Agenda Item: The Grove at Shoal Creek Planned Unit Development

Staff from the City of Austin Development Services and Transportation Departments have reviewed the revised Traffic Impact Analysis for the Bull Creek Parcel development proposal (hereafter called "The Grove") and offer the following comments:

As part of the review of the February 2, 2016 revision of the traffic report regarding the "*The Grove at Shoal Creek, Traffic Impact Analysis*", prepared by R-K Traffic Engineering, LLC, the Austin Transportation Department (ATD) has additional comments related to the final detailed design documents that must be addressed as part of the site plan review process.

Exhibit for approval shows 16.63 acres of parkland:

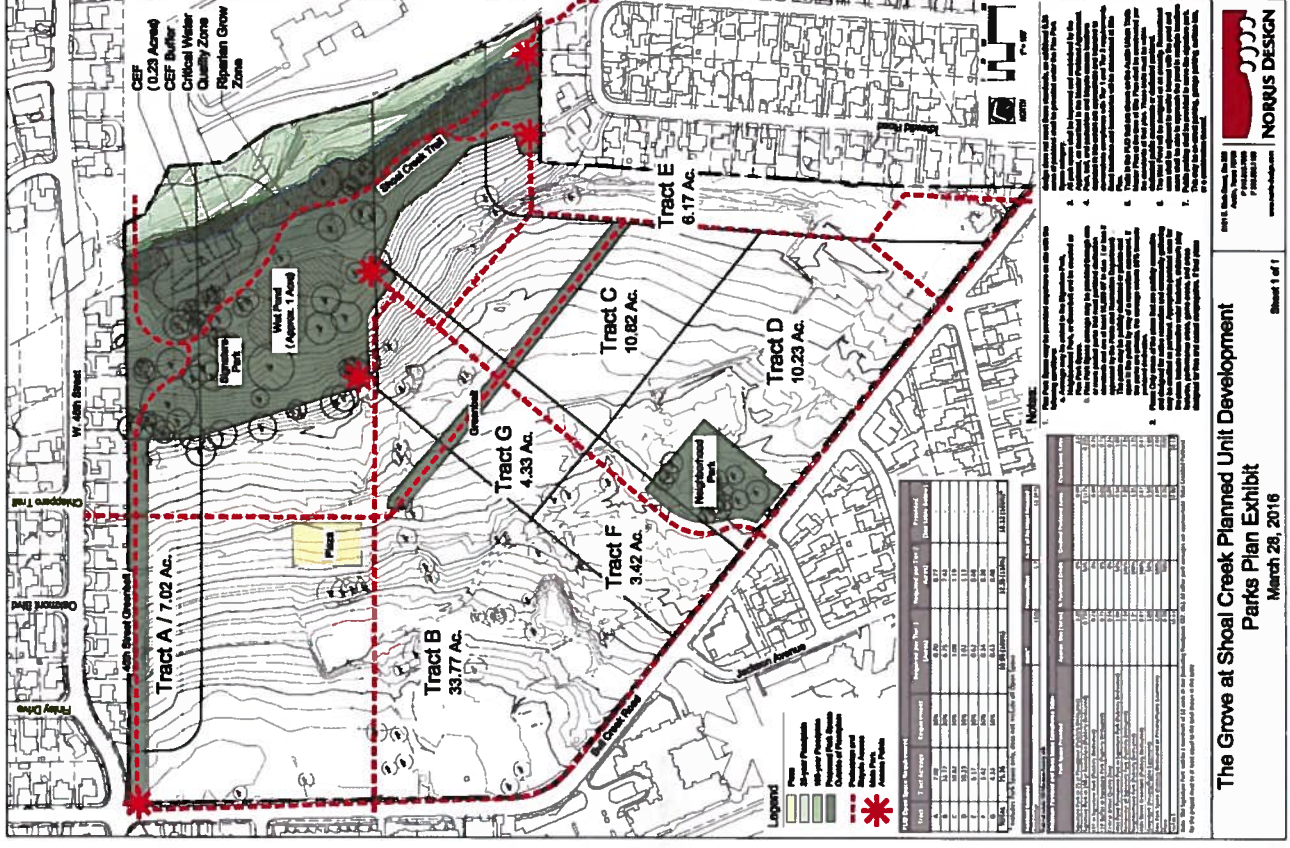
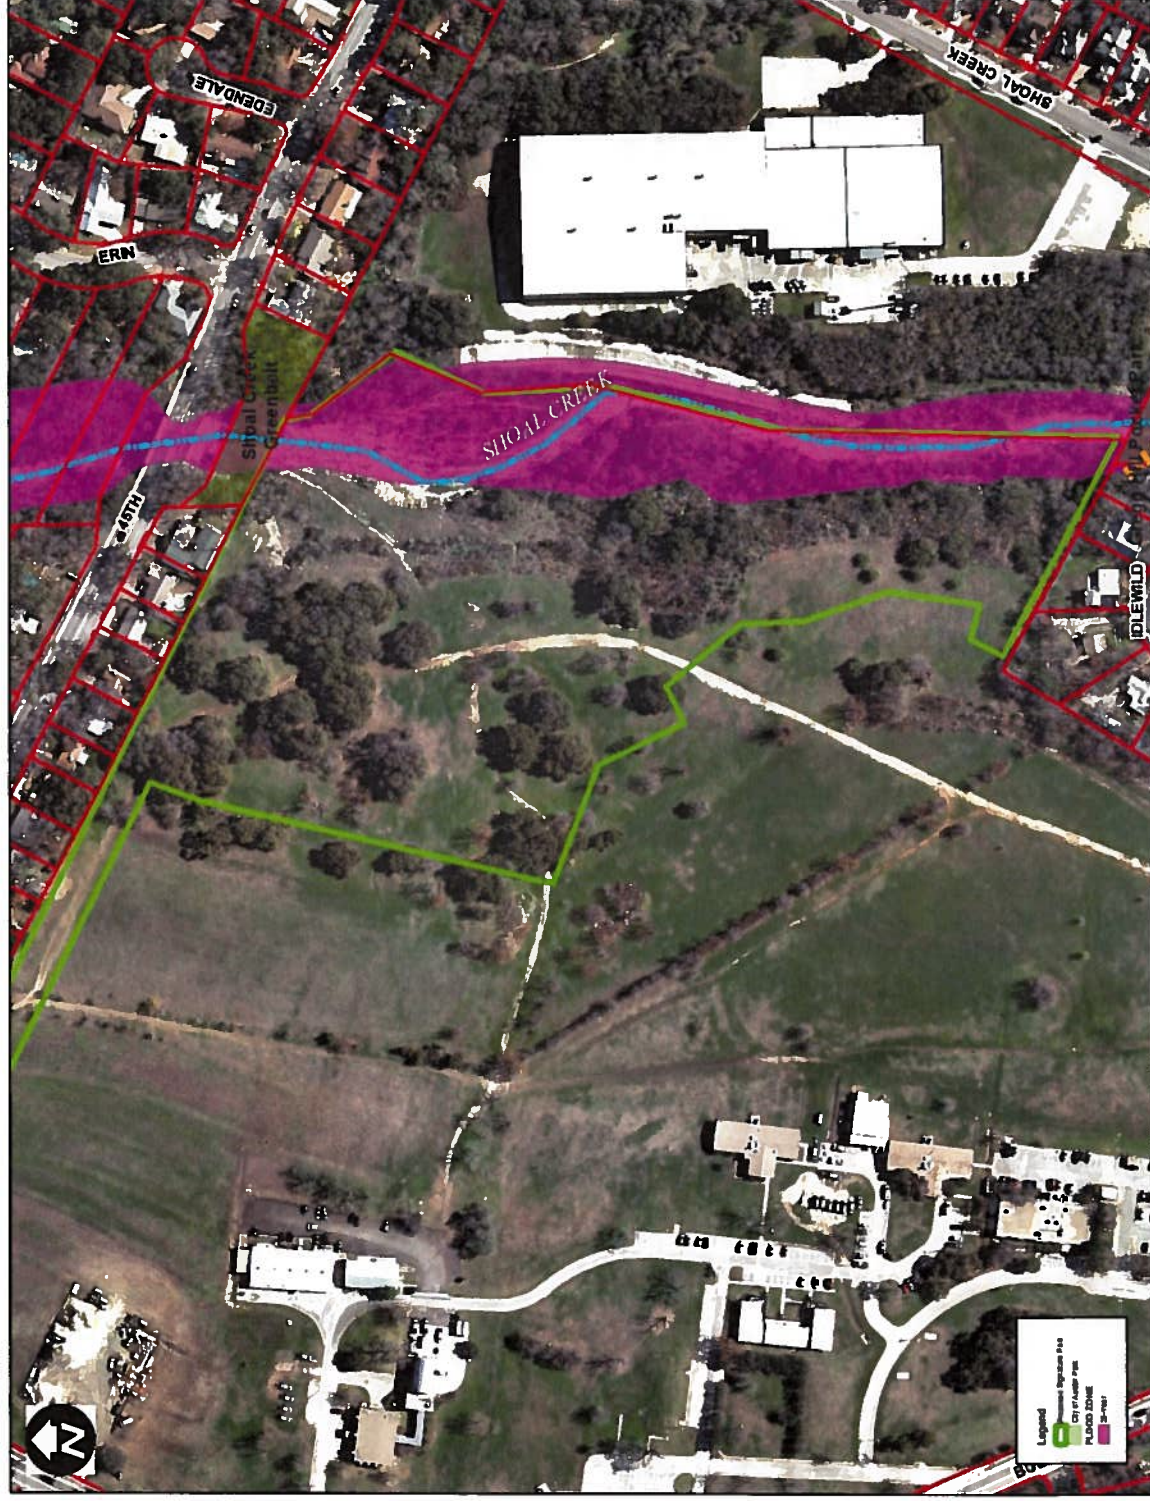
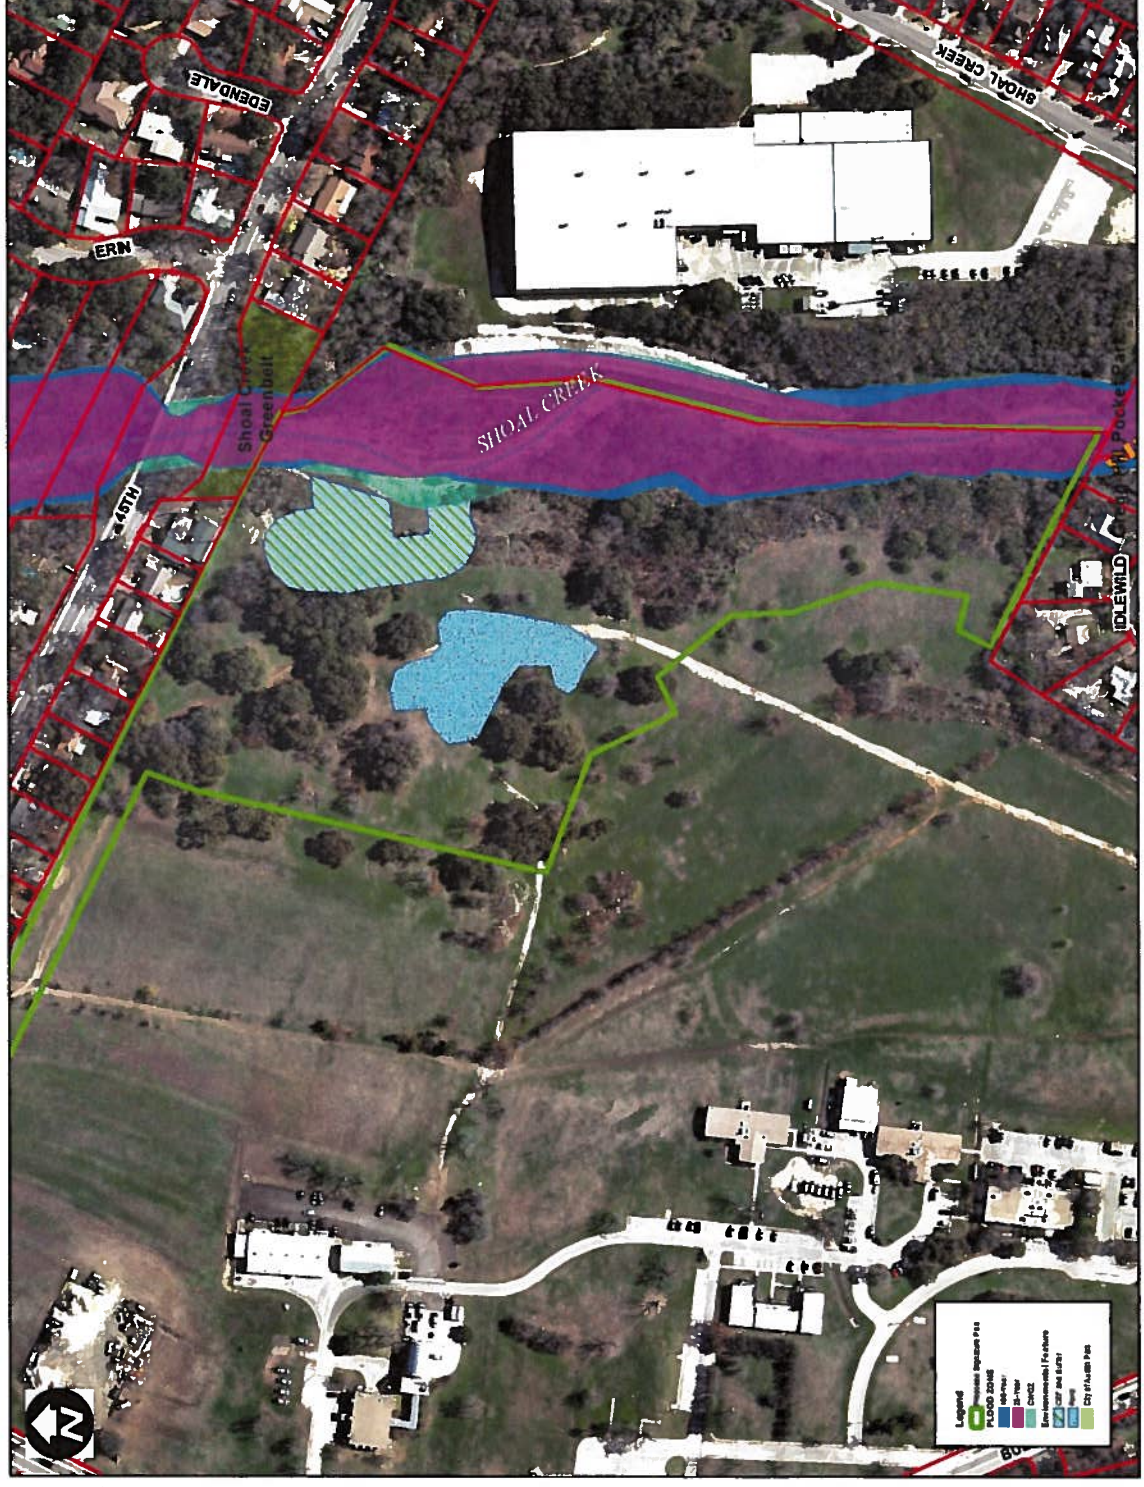
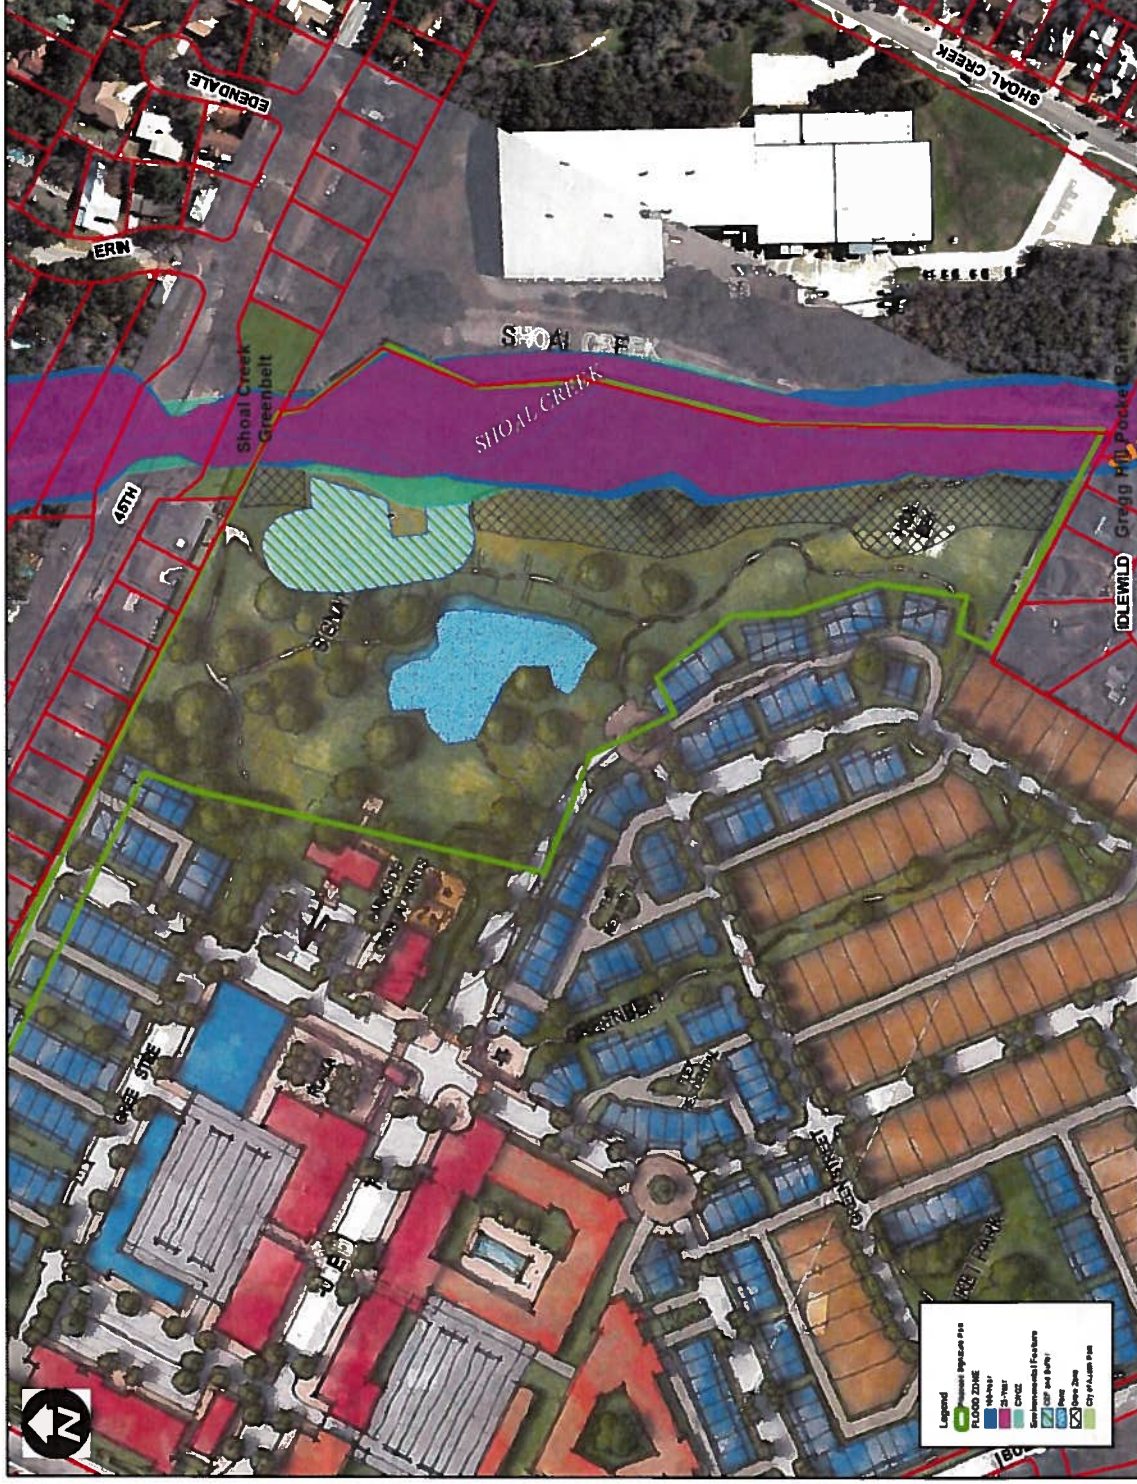
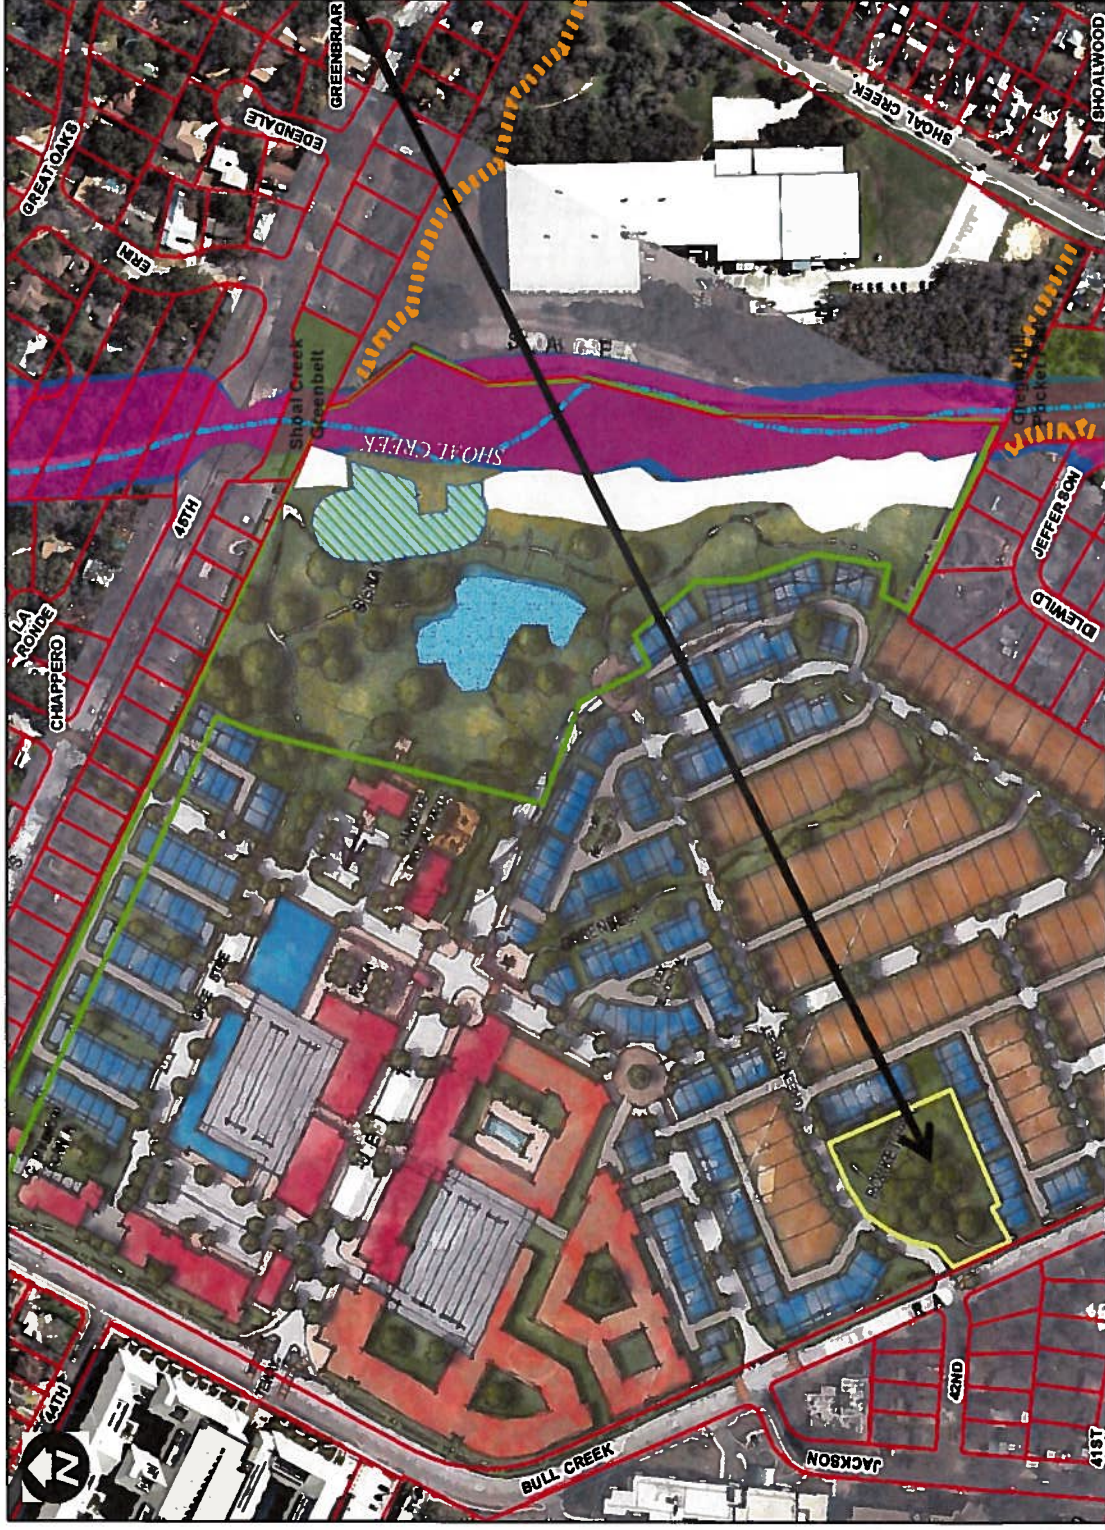
Rationale for frontage and acreage needed to provide the frontage:

- The development along the frontage of most of the Signature Park will hide the park amenities, much as the playscape at Central Market and the Arboreteum cow sculptures are hidden from street view at those developments today. Those are not parkland. They provide an example of how we feel the Applicant's configuration will not address the public realm.

- We need street frontage for superiority, regardless of how much acreage is owed. To this end, we would change Note 8 on the June 7, 2016 Park Exhibit that state: " the signature park should have a minimum of 400 feet of total street frontage" to " the signature park should have a minimum of 1,100 feet of total street frontage. " Also see the attached graphic that extends the proposed park space outside of floodplain to show the street frontage.
